Town of Highland Park, Texas
BOARD OF ADJUSTMENT MEETING
AGENDA

8:30 AM
June 10, 2026

Staff Report

REQUEST: A variance from Section 8-701 to exceed the allowed 40% lot coverage requirement by 1.8%.

ATTACHMENT 4 – CONSTRUCTION PLANS

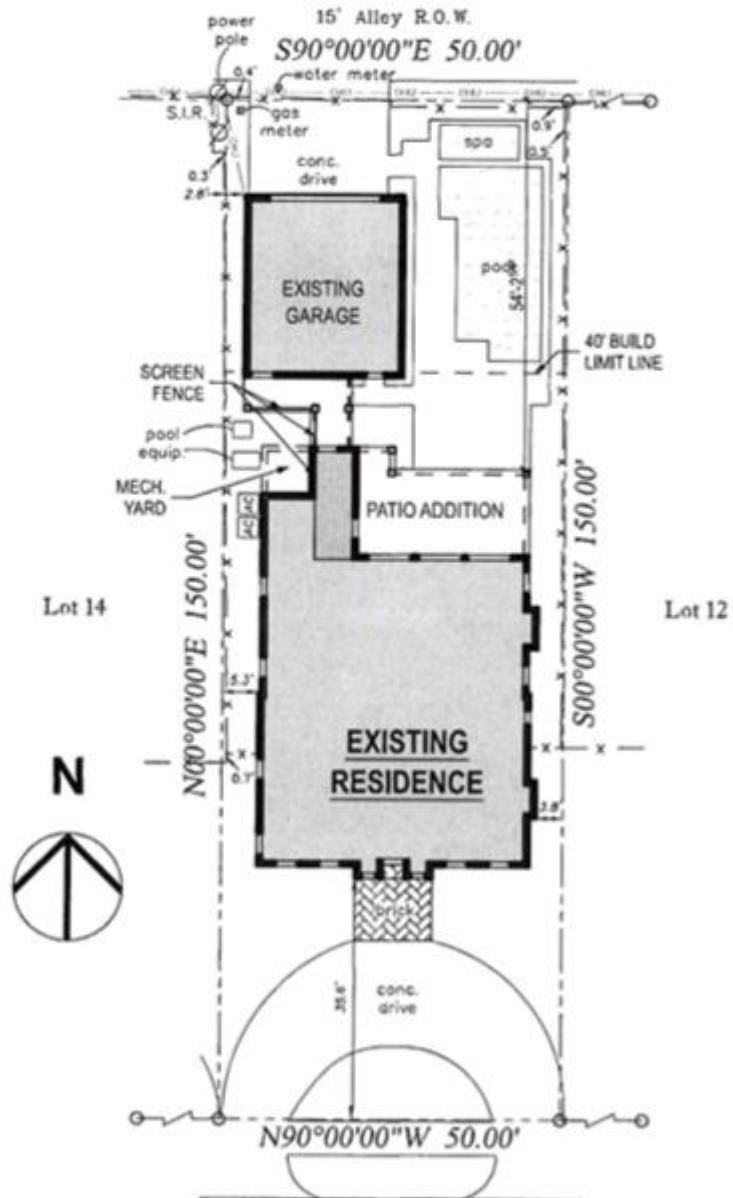
The applicant is planning to build an addition where the existing back patio is currently located, adding additional covered patio area, and constructing a cover over a mechanical yard. Specifically, the areas that would increase the lot coverage beyond the maximum 40% are:

- A 7-foot by 7-foot (49 square feet) cover over the existing mechanical area
- A 5.5-foot by 3.3-foot (18.3 square feet) addition to the existing patio cover
- Total additional square footage is 67.3 square feet

The existing lot coverage of the property is 40.92%, already above the maximum allowed. The additional square footage would increase lot coverage to 41.8%, 1.8% more than the maximum 40% allowed.

Analysis: Staff could find no special conditions to the property other than the existing lot coverage already exceeds the maximum allowed.

Analysis: The primary concerns with lot coverage are effects on storm water runoff and overbuilding a lot to a point that it is out of character with a residential area. In this case the amount of additional lot coverage is minimal and would have little effect on storm water runoff, particularly with no sides on the covers. The additions would likely not be noticeable from outside of the property.

The request does not meet the criteria for a variance and staff recommends denial.
